Our Ref: 26/00050/PRELB
Contact: Mark Simmons
Direct Line: 01462 474685
Email: mark.simmons@north-herts.gov.uk
Date: 2 March 2026

Pre-Application Listed Building: Installation of mezzanine floor, secondary glazing, general repairs, and refurbishment.

Methodist Church, Whitehorse Street, Baldock, Hertfordshire SG7 6QB

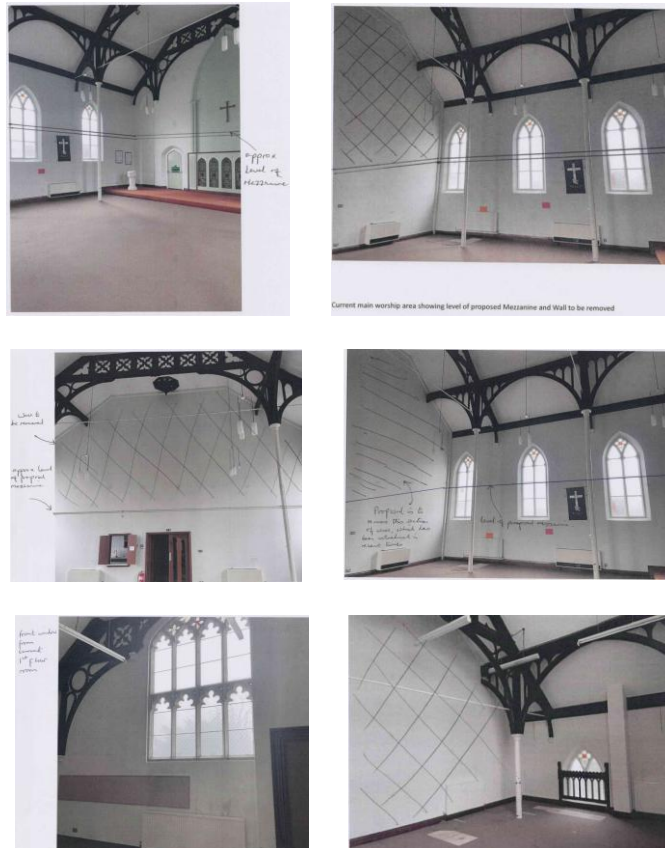
It is noted that the reason why there is no formal determination against app ref: 03/00112/1LB is that the Ecclesiastical Exemption Order applied (see elevation drawing and correspondence below)

The main window on the south east gable has deteriorated extensively, as a result of the iron cramps used, to connect pieces of stone, have rusted, and blown the stone apart at the joints. We believe the window is becoming unstable.

Using a stone mason and specialist glaziers, it is proposed to take down the window, saving the coloured glass, and original etched glass, and rebuild the window. The rebuilt window will replicate the original sections and patterns, and where possible original stone will be re-used.

I am writing to confirm that the proposed works are exempt from Listed Building Consent because the building has an ecclesiastical use. We have retained 2 copies of the plans, for our reference and because the Council must be consulted on this matter, we have also retained the application form and the Specification documentation for our file. I have enclosed the other 2 copies of the plans.

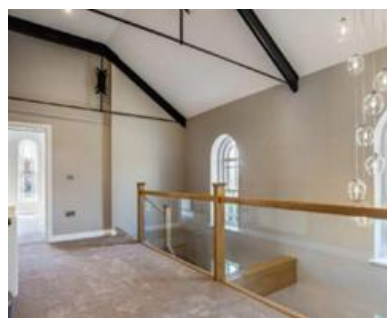
An example as to how the existing first floor visually 'disects' these ground floor windows is expressed in the image immediately above right. Whilst I understand the desire to maximise first floor space and the need to have borrowed light at this level, in my opinion there may be a better way to handle the interface between the floor and windows without having to resort to the visually heavy balustrade treatment. I encourage consideration of a scheme whereby a mezzanine is constructed on the line of metal columns so that the windows are fully expressed at ground floor or possibly something along the lines of the image below.

Having said that, the visuals provided by your architect are really helpful in understanding the relationship between the floor level and windows and how the internal stairs/lift 'box' addresses the first floor space. It is mildly disappointing that the 'box' stands close up to the right-hand reveal to the gable end window. Is there a way in which the staircase can occupy the corner position with the platform lift may be even placed within the central space with the staircase wrapping around the lift, if this enables the 'box' to be pulled back from the window. A fully DDA compliant scheme is supported but I still question whether setting the floor away from the perimeter walls may be a better solution.

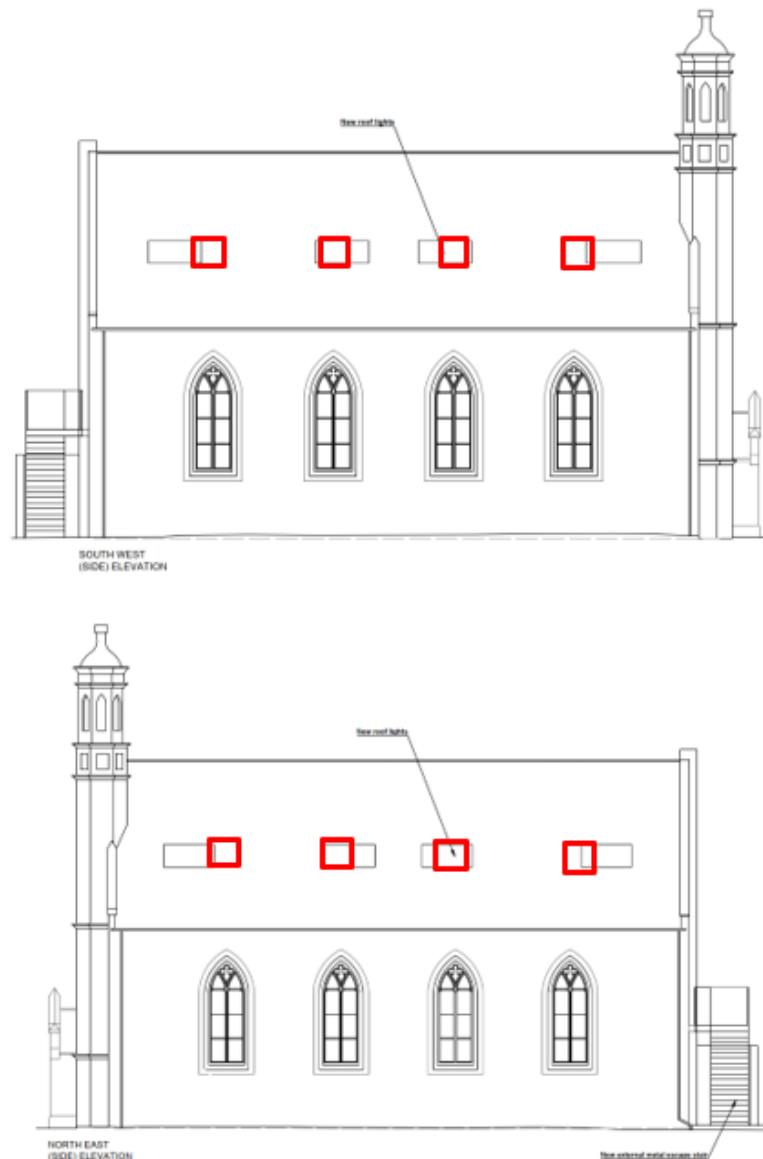
In our telephone conversation last Friday afternoon you requested a steer regarding the windows. I have to say that I have very little contact with secondary glazing companies at the current time. Whilst no objection is raised to the installation of well-detailed secondary glazing and whilst I have seen Selectaglaze's work previously, I see that there are other companies such as the two alternatives below. I confirm that I would not be prepared to support replacement windows (Slimlite glazing or otherwise) unless there was a convincing justification put forward for doing so.

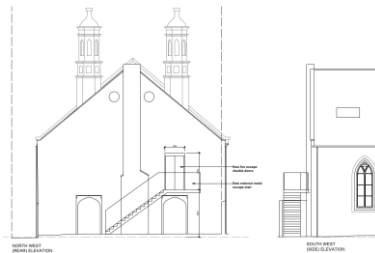
This will require planning permission and listed building consent. The image below refers to this structure possibly incorporating additional toilet facilities thus would not necessarily be fully glazed. This would be located at the front of the listed building and is the most contentious aspect of the current proposal. The proposed reception area (for which no details have been provided) would not only have a significant impact upon the listed building but would also impact upon the character and appearance of the Baldock Conservation Area. It is unlikely that I will be able to support a proposal on heritage grounds.
